Shady Grove Station Public Infrastructure Improvements, Mandatory Referral, MR 2014019

Staff recommends approval to transmit the following comments to the Montgomery County Department of General Services:

Proposed pedestrian crosswalks at Shady Grove Road and Crabbs Branch Way

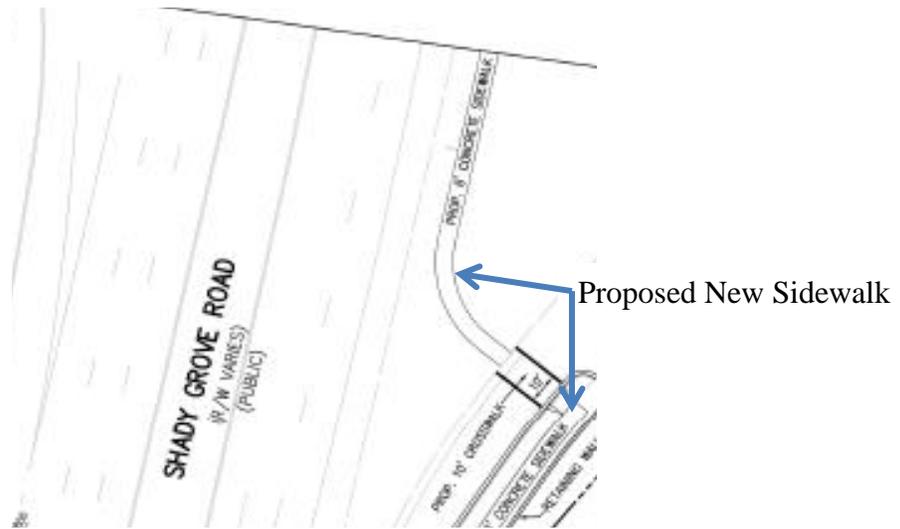
Staff recommends that the Applicant modify turning radii at the eastern and western intersection of Shady Grove Road and Crabbs Branch Way to 30 feet since it would create consistent turning configurations for the street and will further enhance the pedestrian environment.

Proposed trail around the stormwater management pond

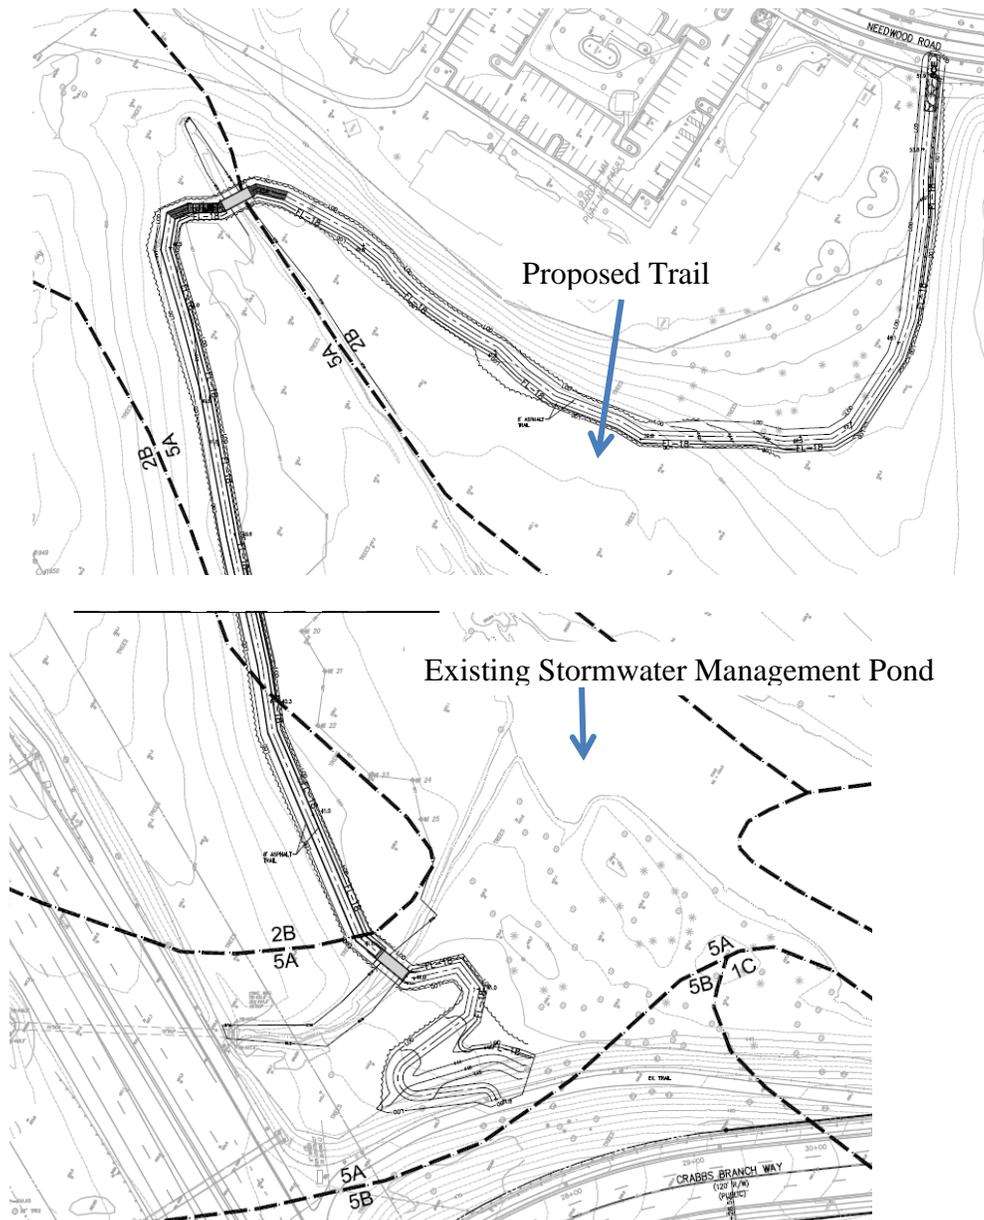
Staff recommends that the Applicant provide directional signage to other public amenities and benches along the trail.
